1958 Agreement:**Consideration of draft amendments to existing****UN Regulations submitted by GRBP****Proposal for Supplement 5 to the 03 series of amendments to
UN Regulation No. 51 (Noise of M and N categories of
vehicles)****Submitted by the Working Party on Noise and Tyres*****Revision 1**

Supplement 5 to the 03 series of amendments to UN Regulation No. 51 (Noise of M and N categories of vehicles)

"Figure 4c

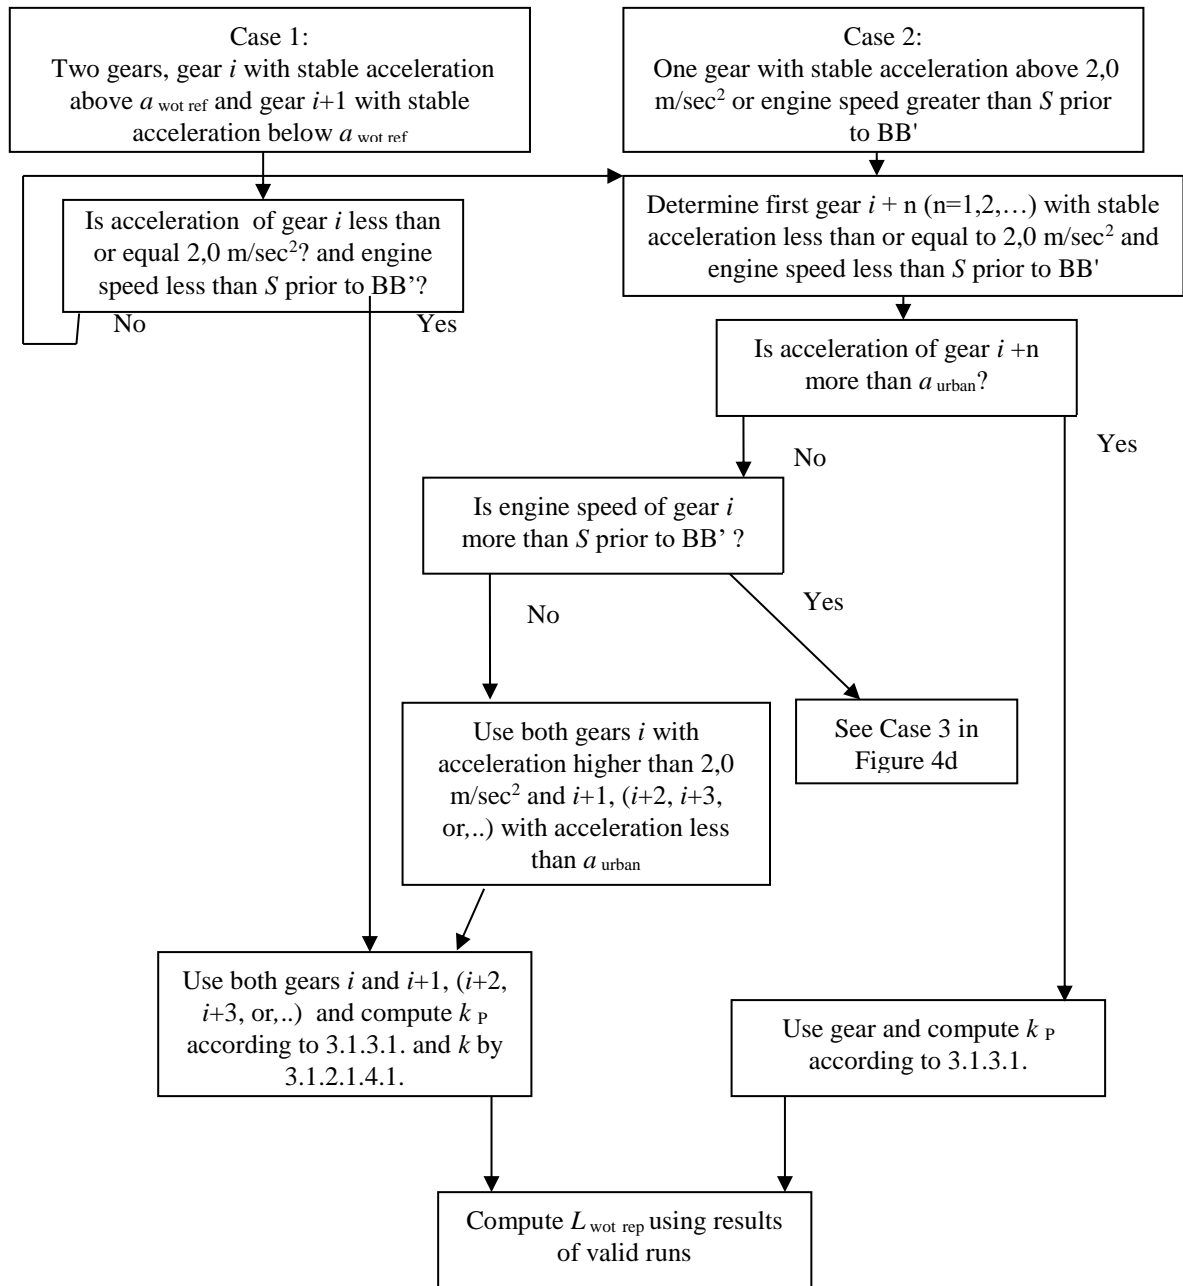
Figure 4c, amend to read:

Flowchart for vehicles tested according to paragraph 3.1.2.1. of Annex 3 to this Regulation – Gear selection using locked gear PART 2"
